Forsyth County Procurement

ADDENDUM #6

RFP 20-78-1620

For: Providing all labor, equipment and materials for the construction of a new Juvenile Justice Center at 875 Lanier 400 Parkway, Cumming, GA 30040. Project includes a multi-phased site development, demolition of existing motel structures and construction of new 62,000 square foot Juvenile Court building.

Sheet No.
A-7.62
RELEASED FOR CONSTRUCTION

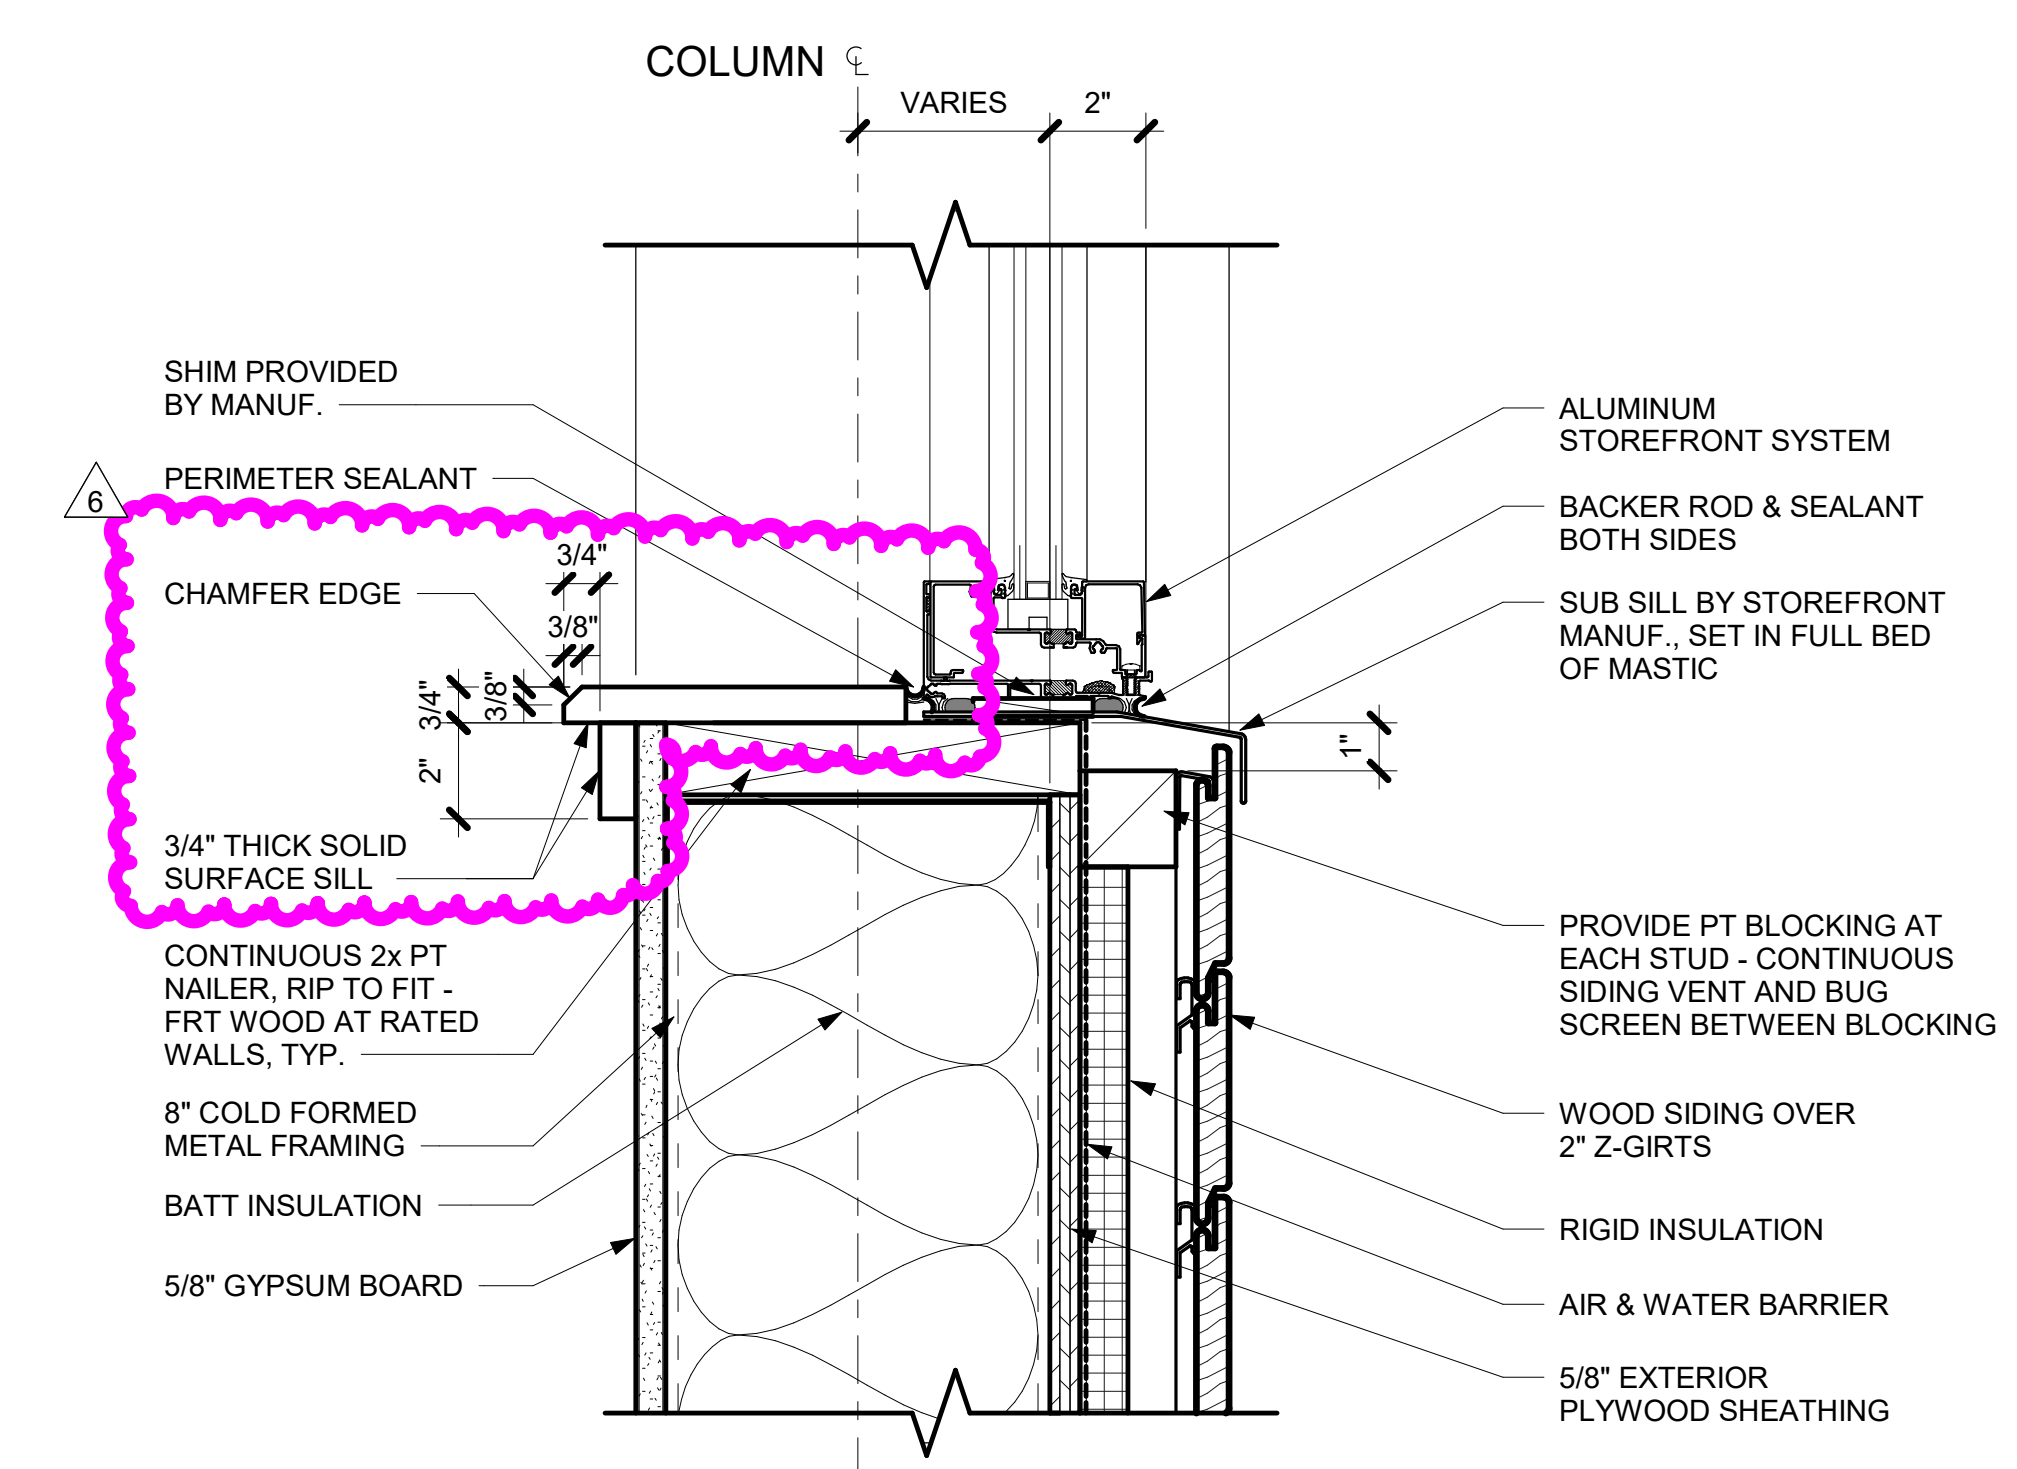
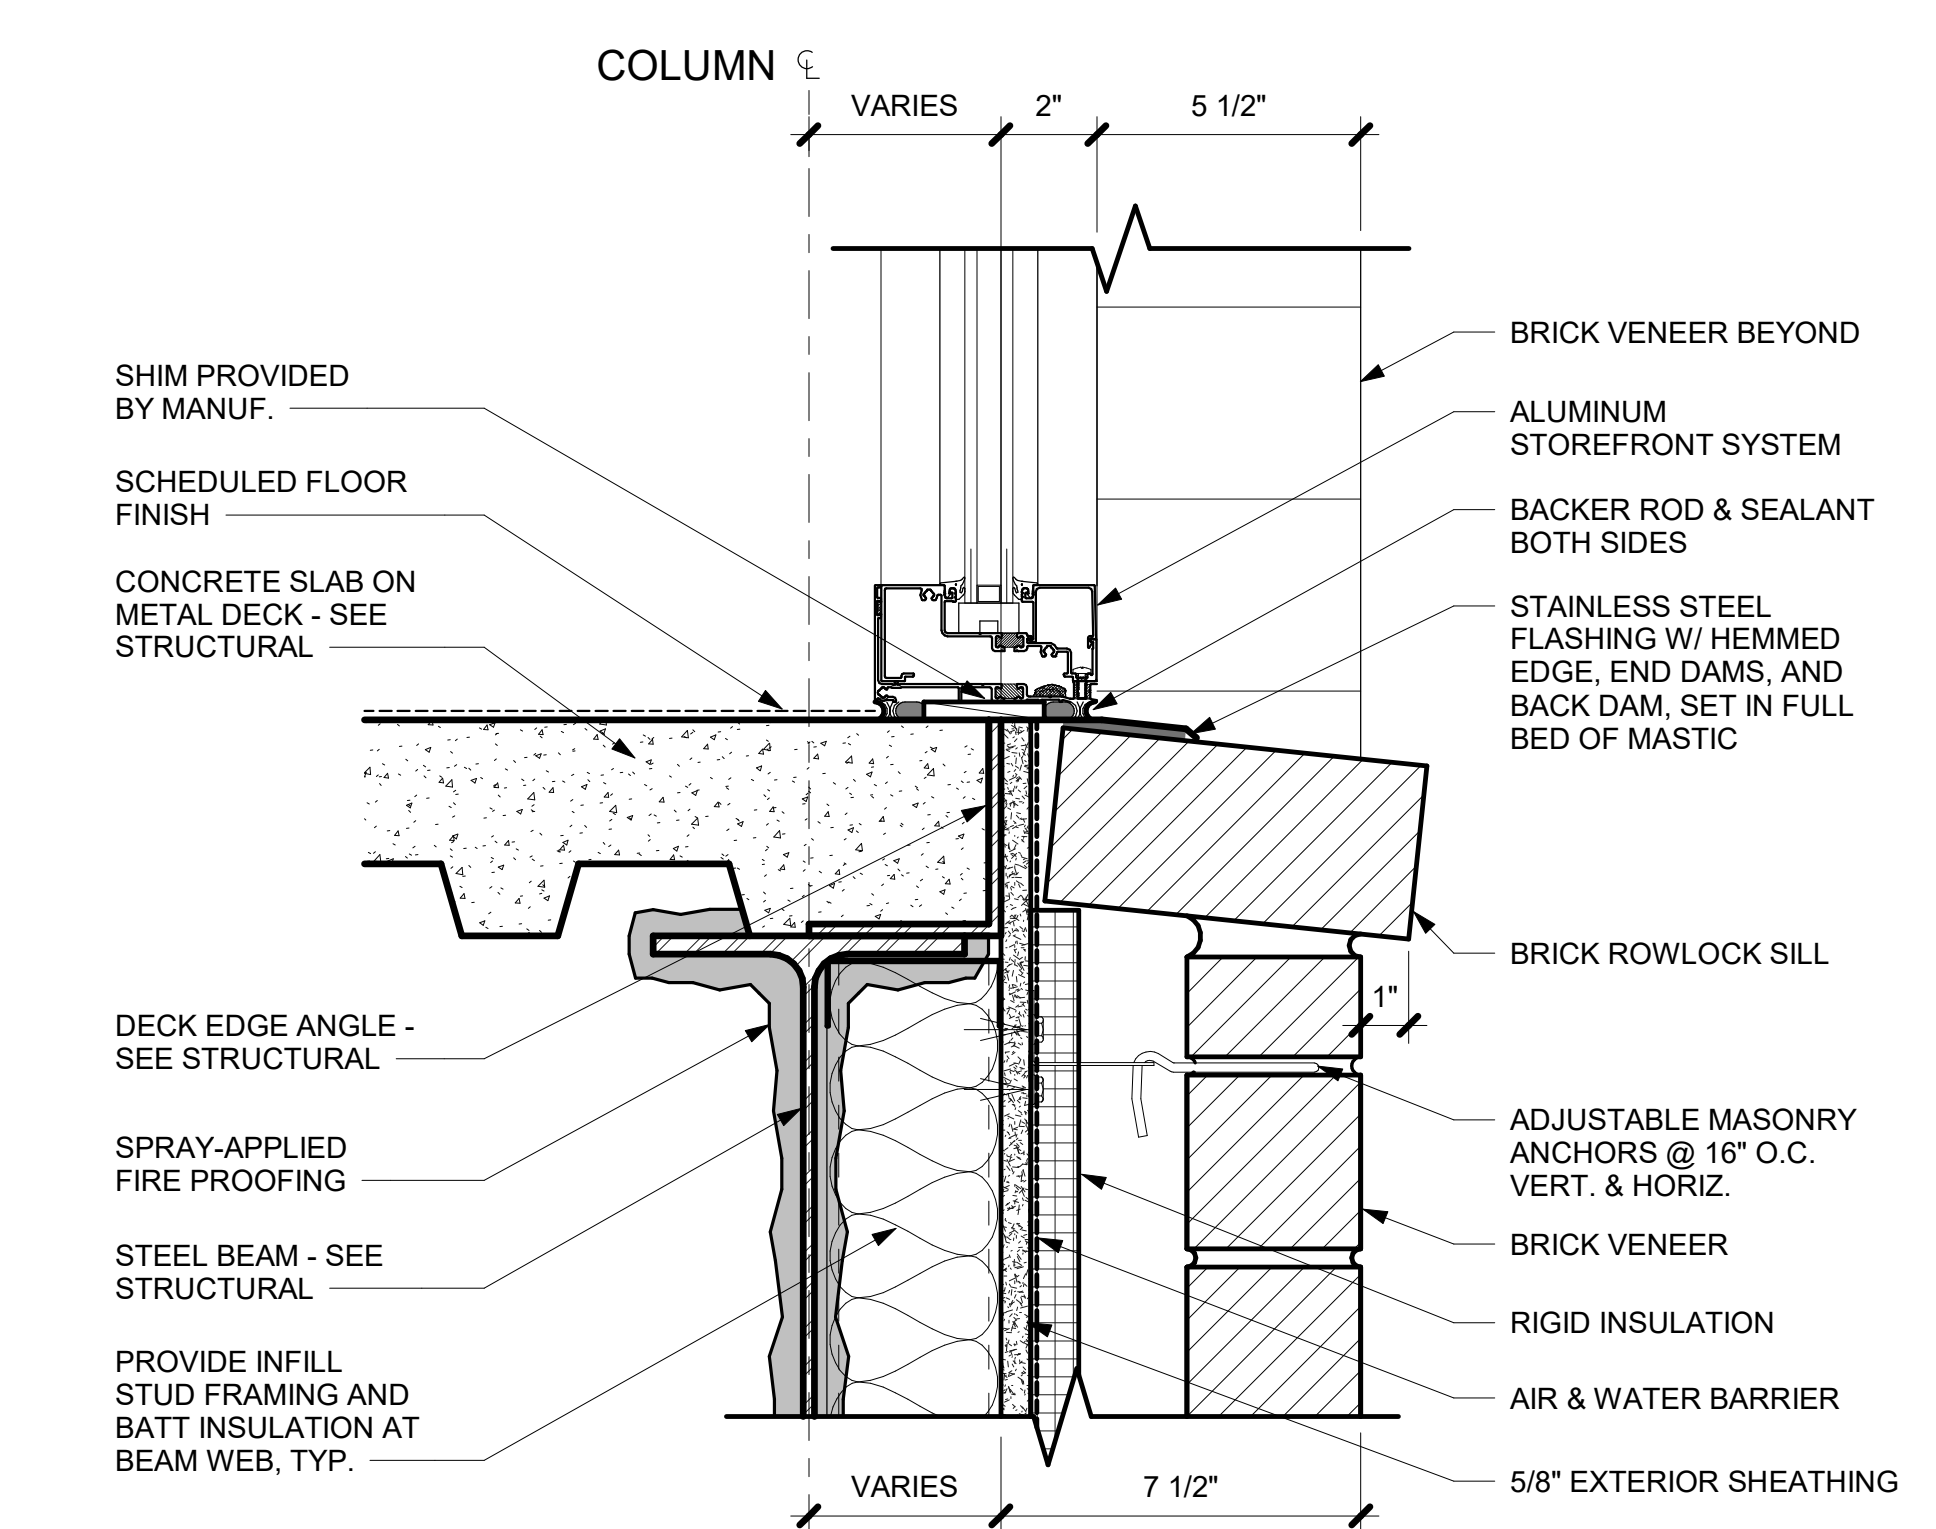
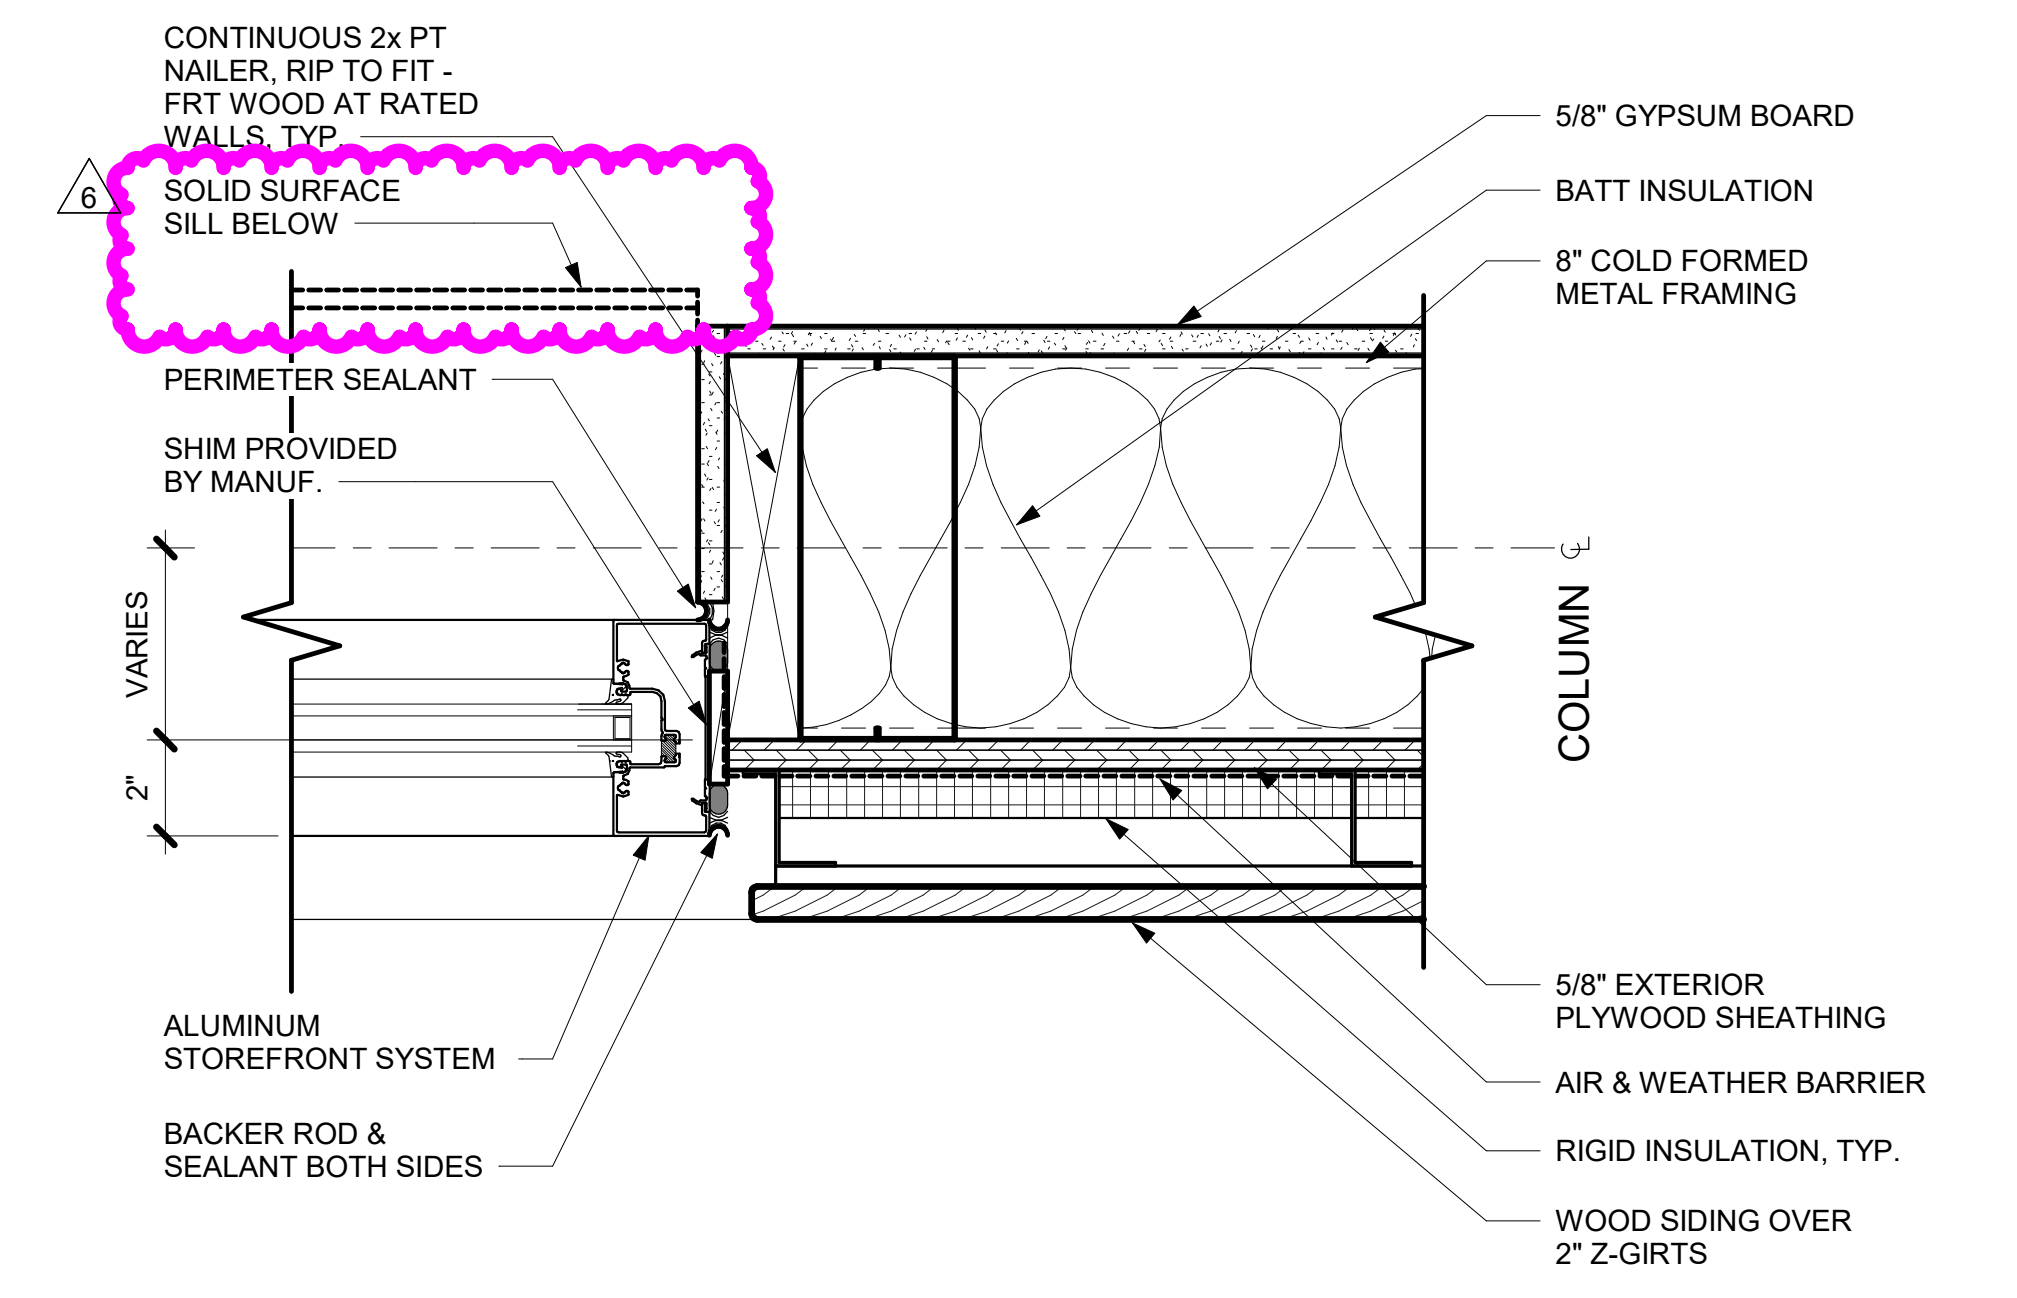
1. Revised sill details to show trim.
2. Reference sheet A-7.62 WINDOW DETAILS revised under addendum #06 dated 07/16/2020.
